SURRY POWER STATION UNIT NO. 2

Amendment No. 6
License No. DPR-37

ATTACHMENT TO LICENSE AMENDMENT NO. 6
CHANGE NO. 21 TO THE TECHNICAL SPECIFICATIONS
FACILITY OPERATING LICENSE NO. DPR-37
DOCKET NO. 50-281

CHANGE NO. 21 TO TECHNICAL SPECIFICATIONS

FIGURE 2.1-1 REACTOR CORE THERMAL & HYDRAULIC SAFETY LIMITS-
THREE LOOP OPERATION, 100% FLOW

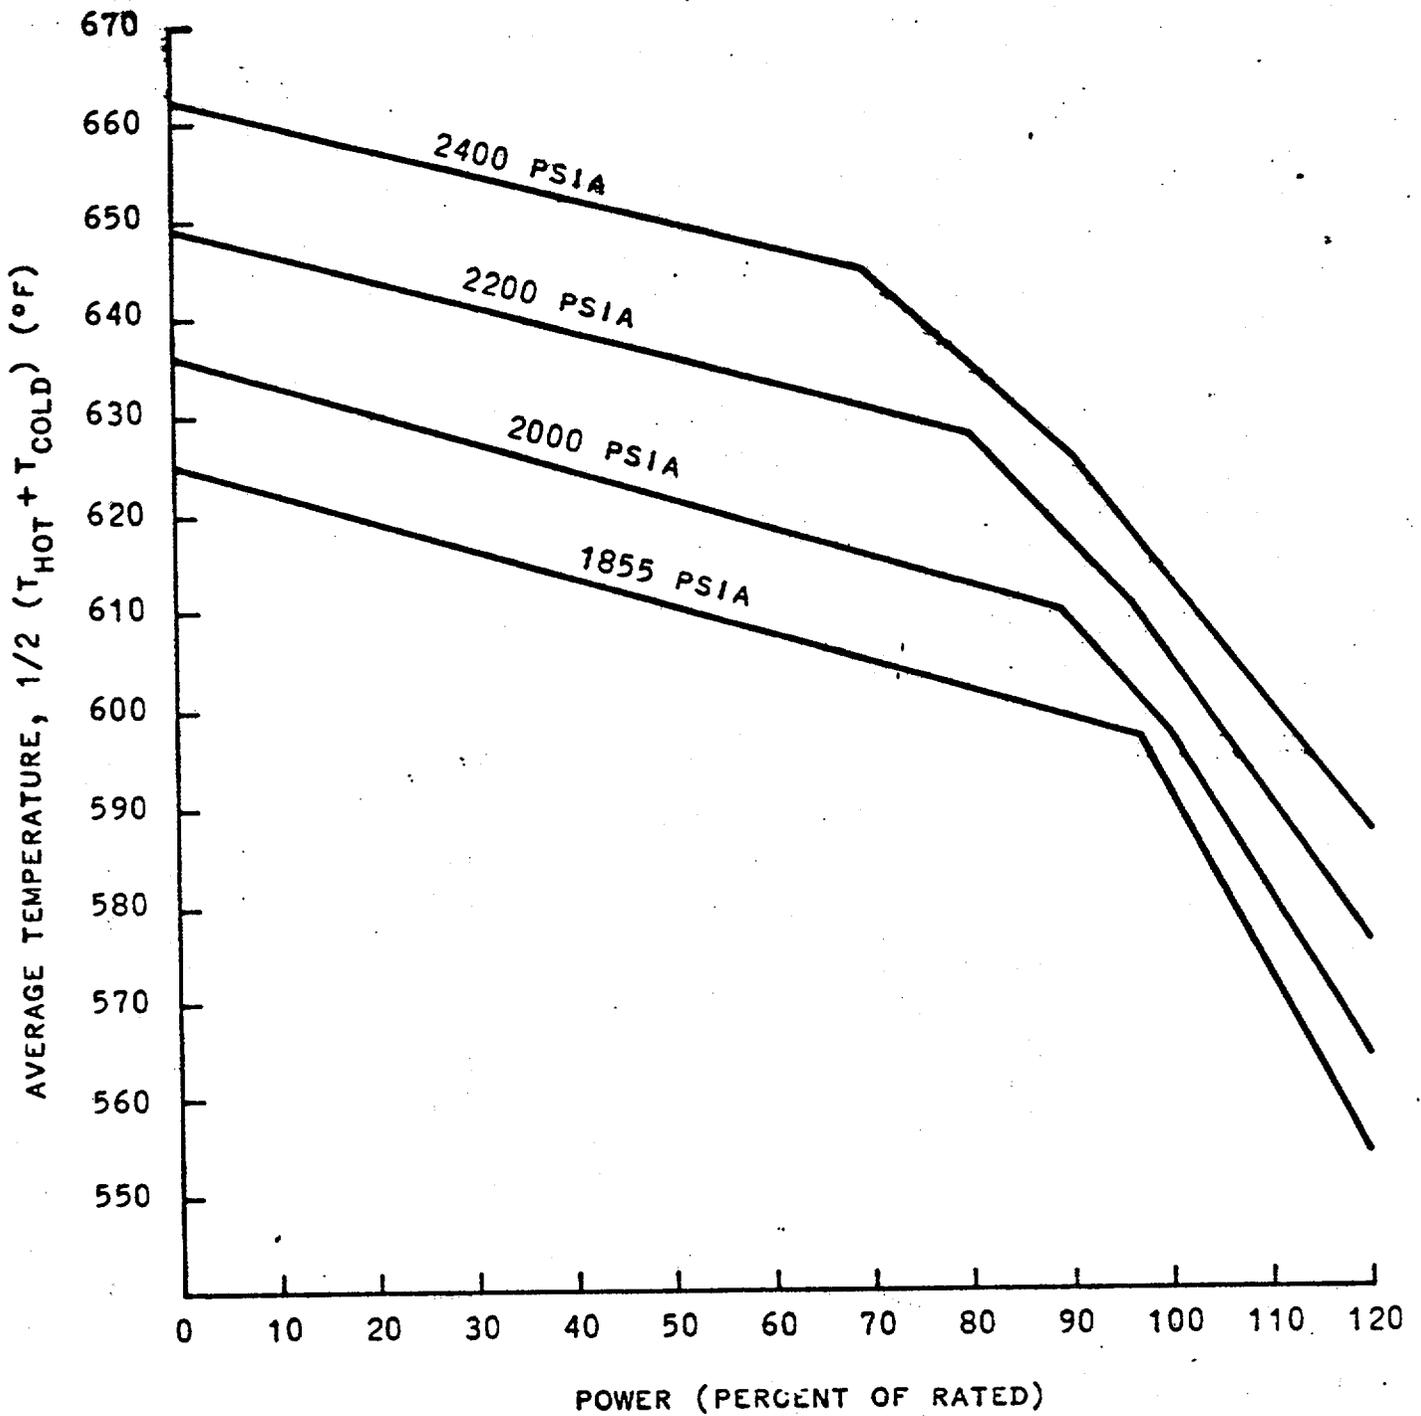
The curves of TS Figure 2.1-1 which show the allowable power level decreasing with increasing temperature at selected pressures for constant flow (three loop operation) represent limits equal to, or more conservative than, the loci of points of thermal power, coolant system average temperature, and coolant system pressure for which the DNB ratio is equal to 1.30 or the average enthalpy at the exit of the core is equal to the saturation value. The area where clad integrity is assured is below these lines. The temperature limits are considerably more conservative than would be required if they were based upon a minimum DNB ratio of 1.30 alone but are such that the plant conditions required to violate the limits are precluded by the self-actuated safety valves on the steam generators. The three loop operation safety limit curve has been revised to allow for heat flux peaking effects due to fuel densification.

TS Figures 2.1-1 through 2.1-3 are based on a $F_{\Delta H}^N$ of 1.55, a 1.55 cosine axial flux shape and a DNB analysis as described in Section 4.3 of the report Fuel Densification Surry Power Station, Unit 1 dated December 6, 1972 (including the effects of fuel densification). They also include an allowance for an increase in the enthalpy rise hot channel factor based on the expression:

FIGURE 2.1-2 REACTOR CORE THERMAL AND HYDRAULIC SAFETY LIMITS, TWO LOOP OPERATION, LOOP STOP VALVES OPEN

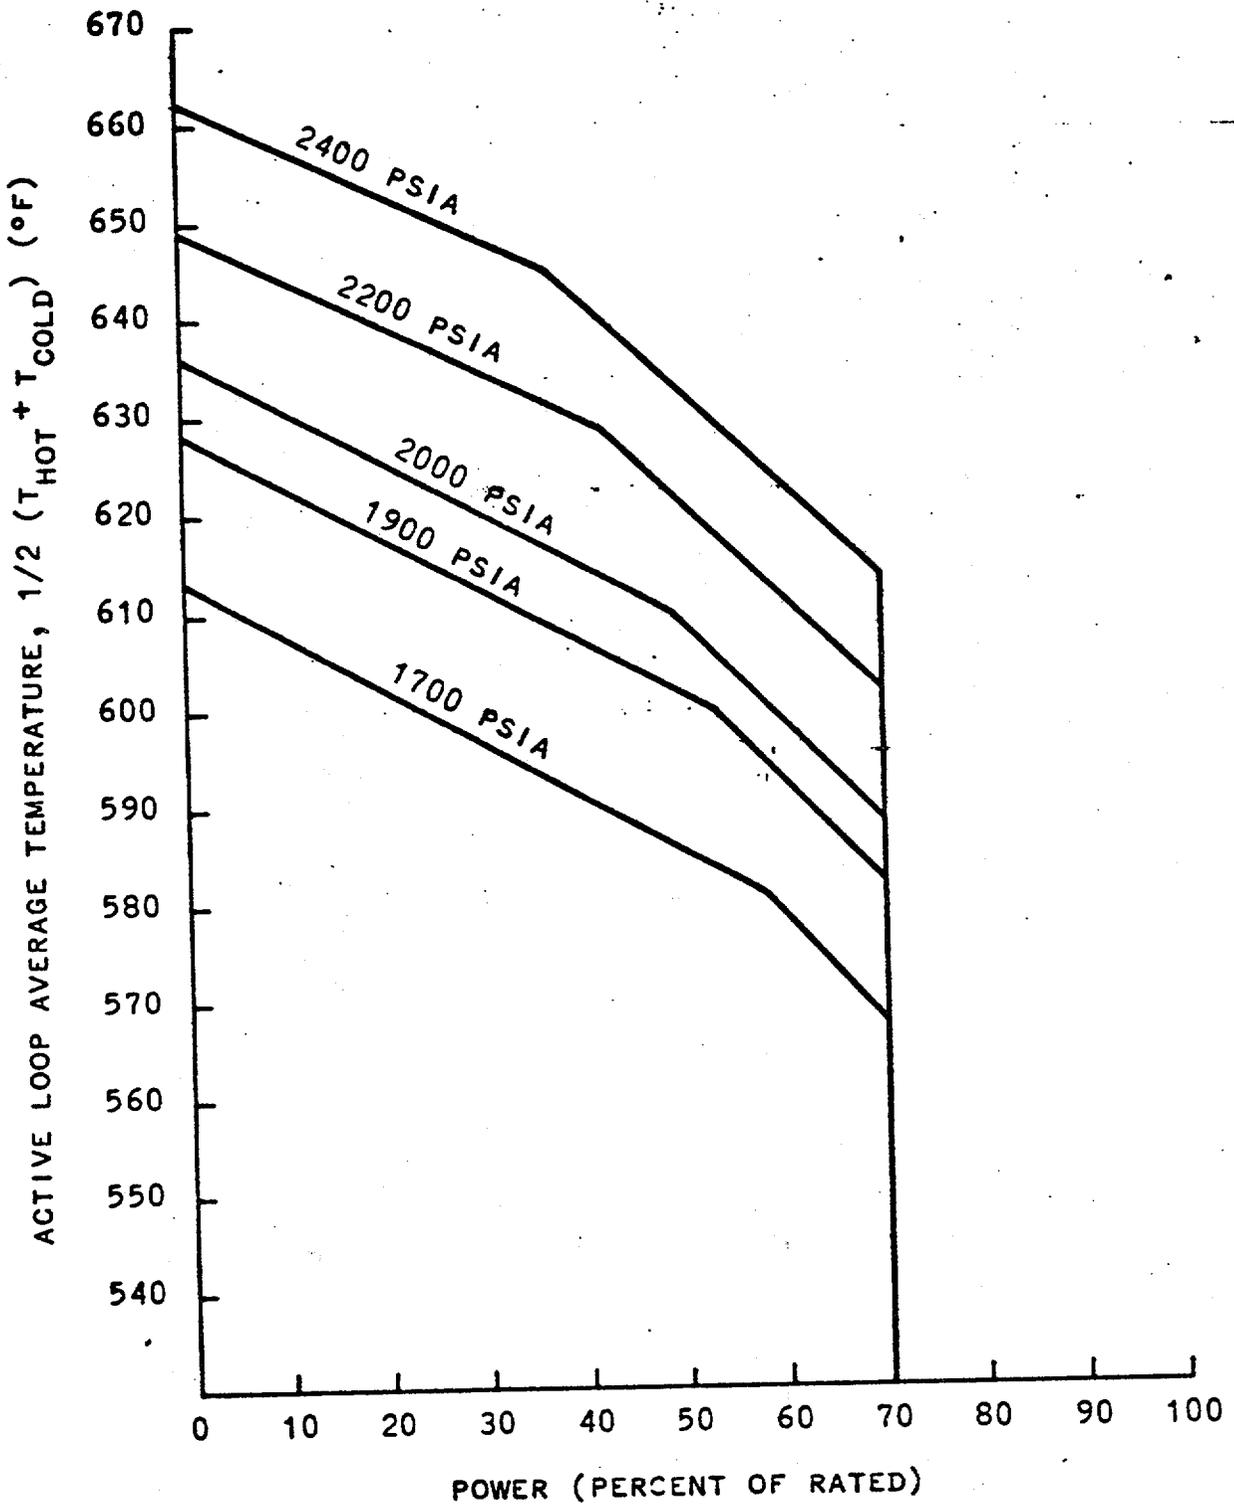
The curves of TS Figures 2.1-2 and 2.1-3 which show the allowable power level decreasing with increasing temperature at selected pressures for constant flow (two loop operation), represent limits equal to, or more conservative,

FIGURE 3.12-1B CONTROL BANK INSERTION LIMITS FOR NORMAL 3 LOOP OPERATION-UNIT NO. 2

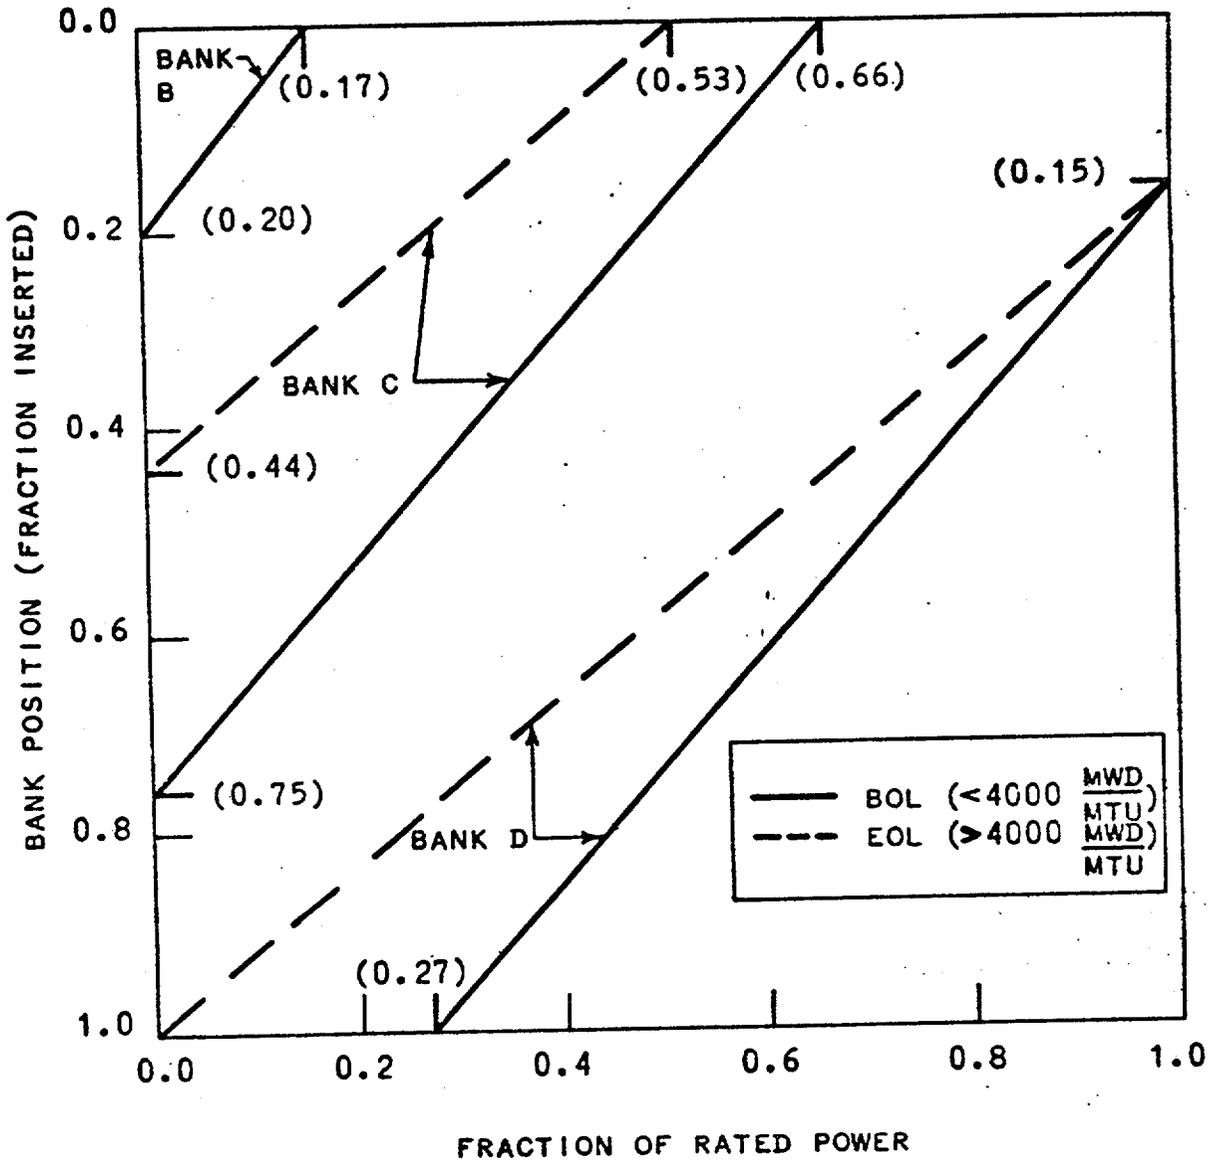
The changes to Section 3.12 proposed by the licensee in Technical Specification Change No. 27 involve replacement of Figures 3.12-1B and 4B, control rod insertion limits for three- and two-loop operation, with the Unit 2 cycle 2 reload analysis. The insertion limits maintain the shutdown margin throughout cycle life as well as maintaining potential ejected rod worth and power distribution within the limits used in the accident analysis and are acceptable as proposed.
